UNITED STATES PATENT AND TRADEMARK OFFICE

APPLICATION NO.	FILING DATE	FIRST NAMED INVENTOR	ATTORNEY DOCKET NO.	CONFIRMATION NO
09/748,277	12/27/2000	Jae-Lag Ma	8733.363.00	4729
30827 75	590 05/02/2003			
MCKENNA LONG & ALDRIDGE LLP			EXAMINER	
1900 K STREET, NW WASHINGTON, DC 20006			RUDE, TIMOTHY L	
		•	ART UNIT	PAPER NUMBER
	•		2871	
			DATE MAIL ED. 05/02/2002

A				
	Application No.	Applicant(s)				
	09/748,277	MA ET AL.				
Office Action Summary	Examin r	Art Unit				
	Timothy L Rude	2871				
The MAILING DATE of this communication appears on the cover she t with the correspondenc address Period for Reply						
A SHORTENED STATUTORY PERIOD FOR REPLY IS SET TO EXPIRE 3 MONTH(S) FROM THE MAILING DATE OF THIS COMMUNICATION. - Extensions of time may be available under the provisions of 37 CFR 1.136(a). In no event, however, may a reply be timely filed after SIX (6) MONTHS from the mailing date of this communication. - If the period for reply specified above is less than thirty (30) days, a reply within the statutory minimum of thirty (30) days will be considered timely. - If NO period for reply is specified above, the maximum statutory period will apply and will expire SIX (6) MONT

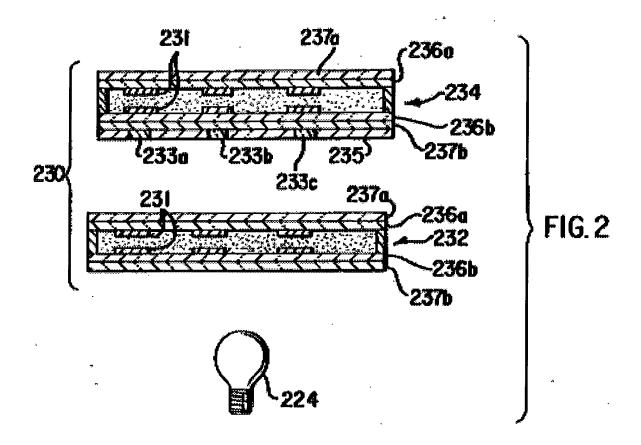
As to claims 6 and 9-11, Dingwall teaches in Figures 2 and 3 (col. 5, lines 33-40 and col. 7, line 60 through col. 8 line 28), a liquid crystal display (LCD) device, comprising:

an upper polarizer, 237a; on an upper substrate, 236a;

a lower substrate, 236b, on a lower polarizer, 237b, (Applicant's redundant lower substrate); a liquid crystal layer disposed between the upper substrate and the lower substrate; and a backlight device, 224, disposed opposite the lower polarizer for emitting light toward the lower polarizer (Figure 4);

wherein the lower polarizer includes at least one opaque surround or black mask, 235, (Applicant's light shielding film), formed in a rectangular shape along the peripheral portion of the lower polarizer (235 shaped to run along all four sides of the rectangular lower polarizer as illustrated in Figure 3) wherein the black mask absorbs light (col. 8, lines 29-33, and col. 13, lines 25 and 26).

FIG. 3

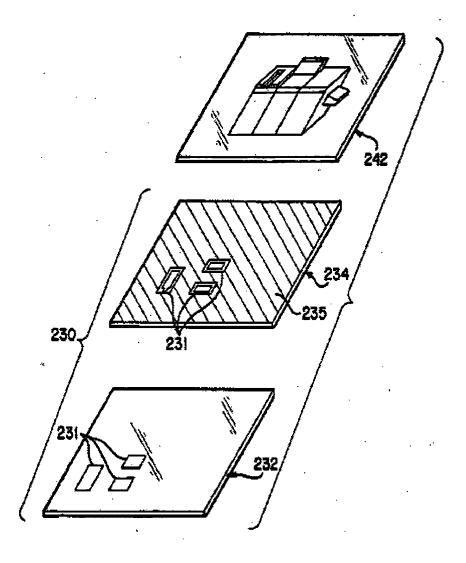
As to claims 7 and 8, Dingwall teaches (col. 8, lines 11-28) a liquid crystal display (LCD) device of claim 1, wherein the at least one opaque surround or black mask, 235, (Applicant's light shielding film) is formed by a photographic process, by offset lithography (Applicant's coating), or by screen printing (Applicant's printed material) black mask materials that absorb the light (col. 8, lines 29-33, and col. 13, lines 25 and 26).
